To: Newton Board of Aldermen
From: Stephen J. Buchbinder, Esquire
Re: The Station at Riverside/Special Permit Petition #258-12
Date: November 13, 2012

Re: Station at Riverside Redevelopment
Response To Alderman Comments
October 2012 LUC Hearing

Re: Station at Riverside Redevelopment
Response To Alderman Comments
October 2012 LUC Hearing

Attachment C
Williams School Access from Lower Falls

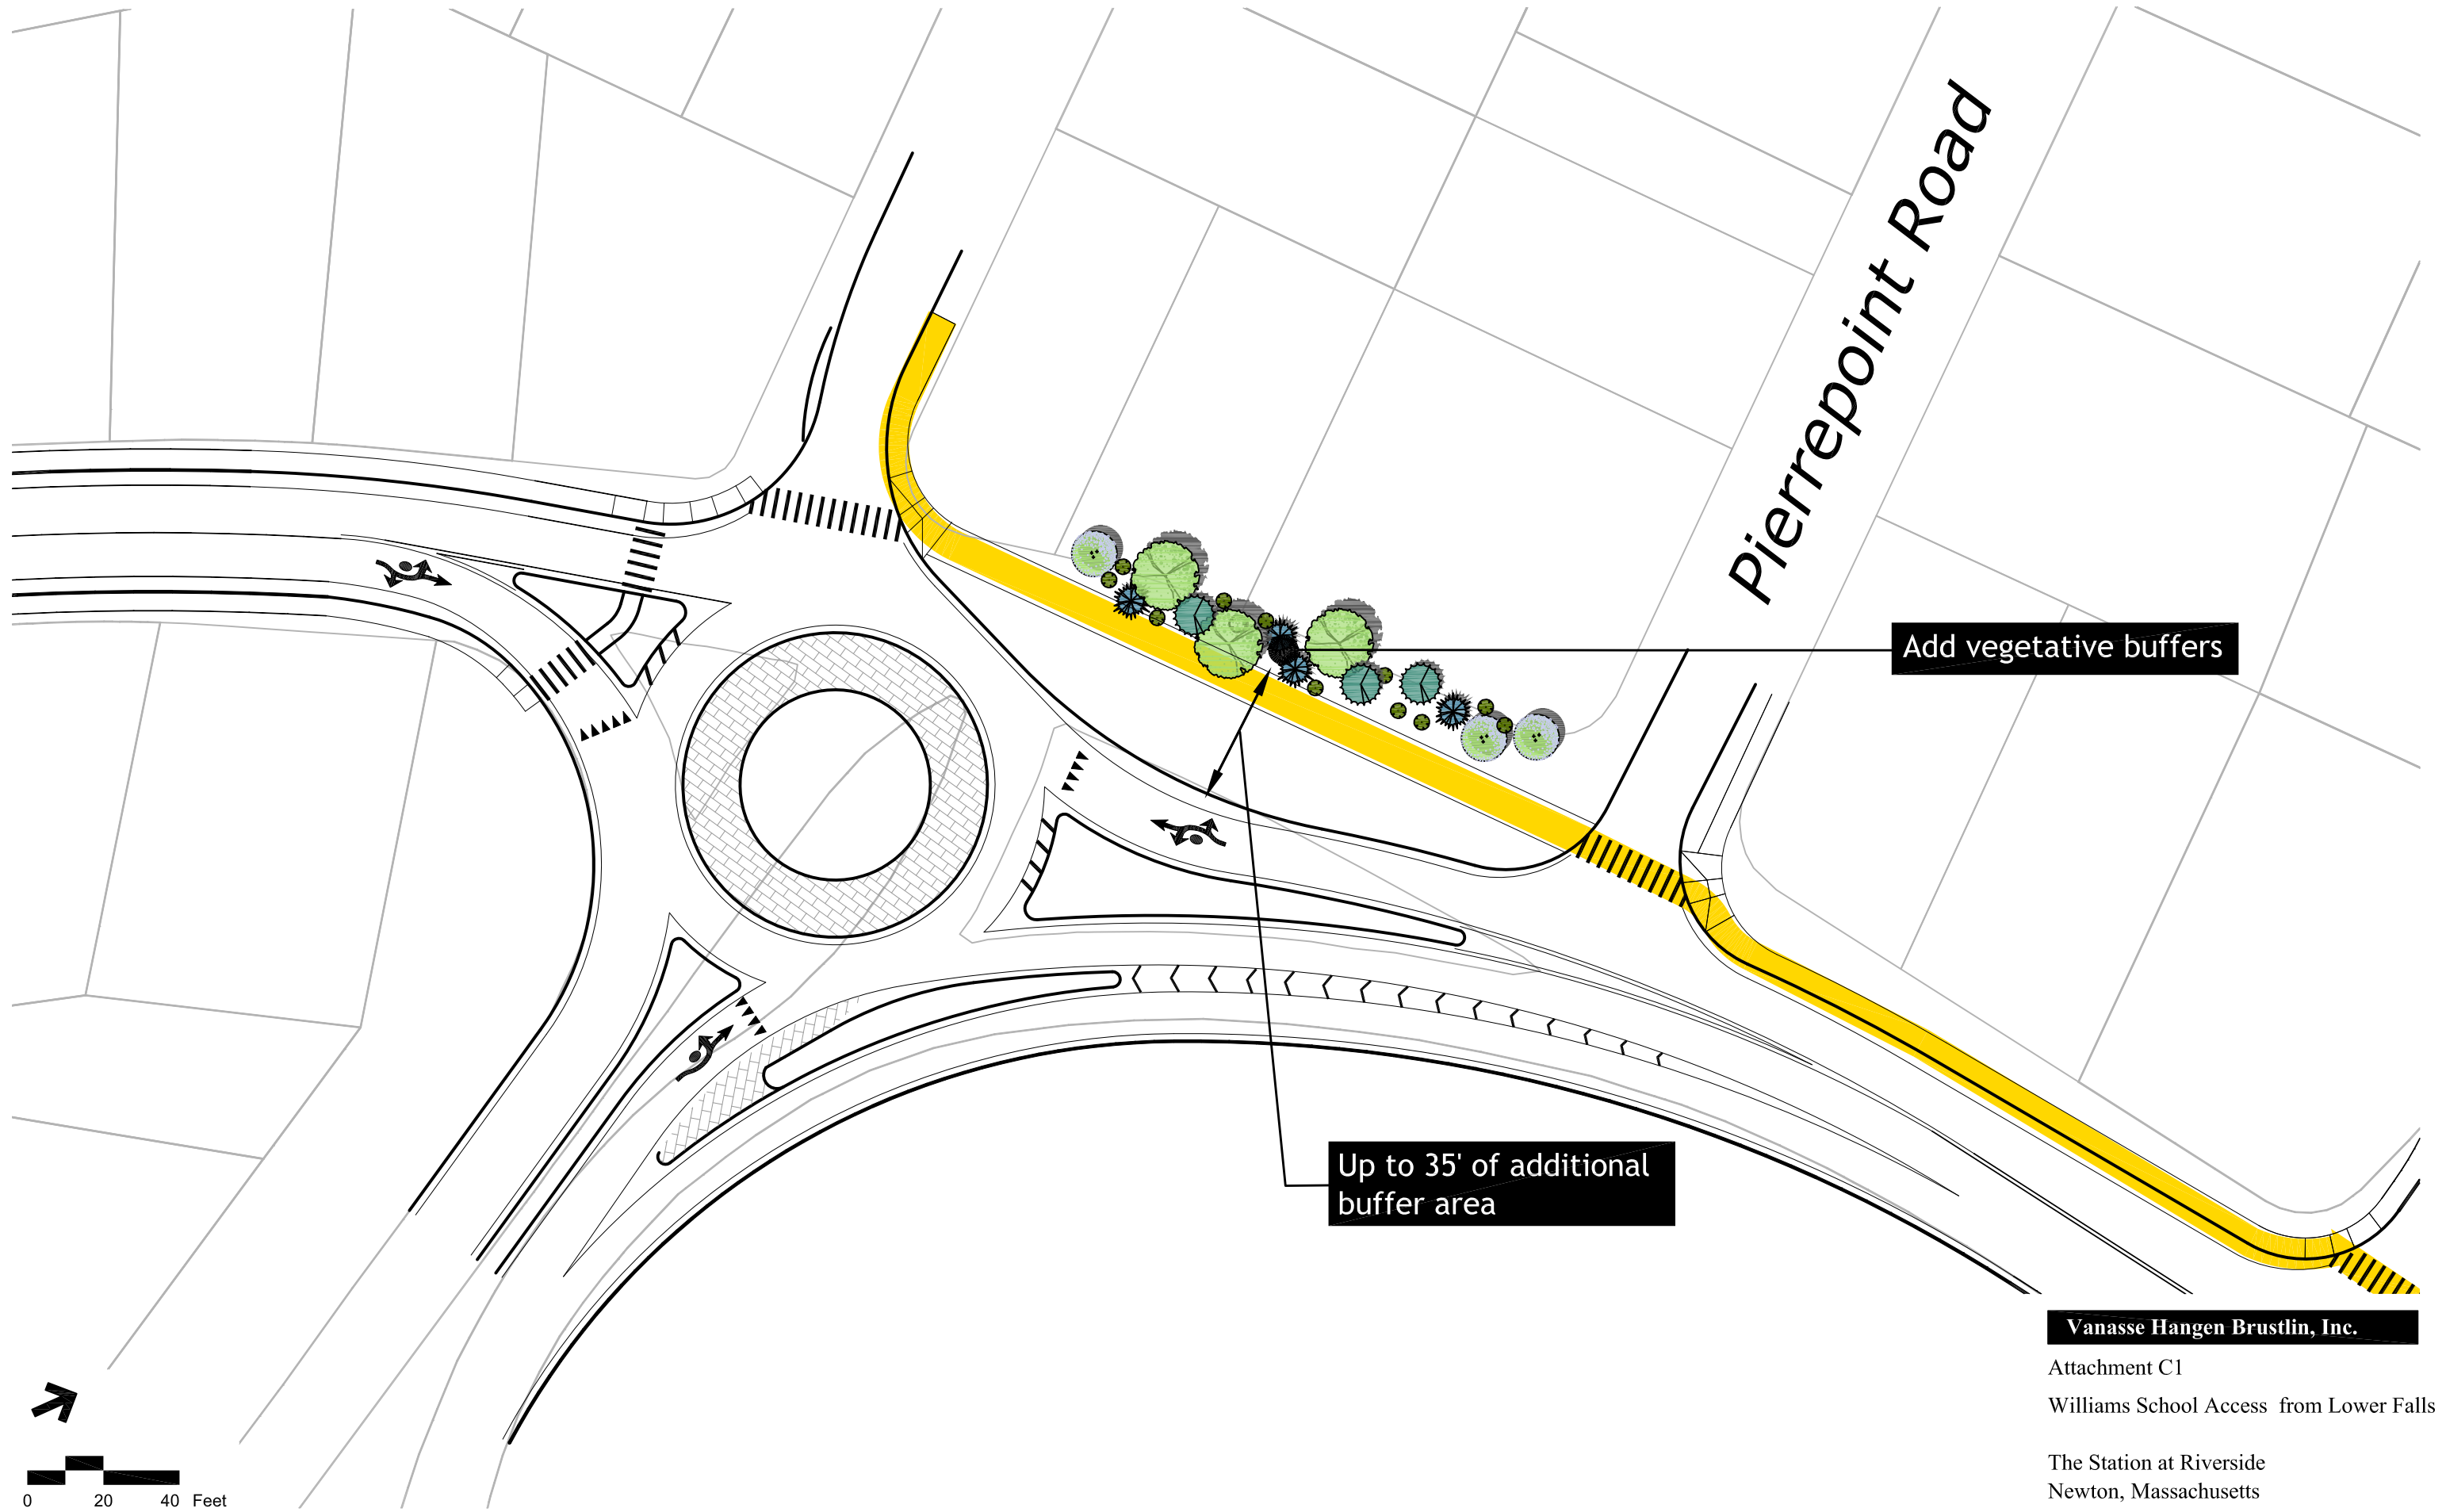
Comment: *How will children walk to the Williams School from NLF?*

Response: Strong pedestrian connections are being made from the Lower Falls area to the site and beyond. Sidewalk is proposed across the Route 128 Bridge and a pedestrian crosswalk is proposed across the CD Road ramp just north of the roundabout. As represented to the community on numerous occasions during the development of the project, the Proponent will provide a crossing guard at this location during the morning and afternoon school arrival and departure periods to assist children crossing this location. In addition, a sidewalk is provided along the entire project frontage of Grove Street so there essentially will be a dedicated pedestrian sidewalk all the way from Lower Falls past the site and ultimately leading to the Williams School. See attachment C, C-1, C-2, and C-3 which demonstrates the walking path.
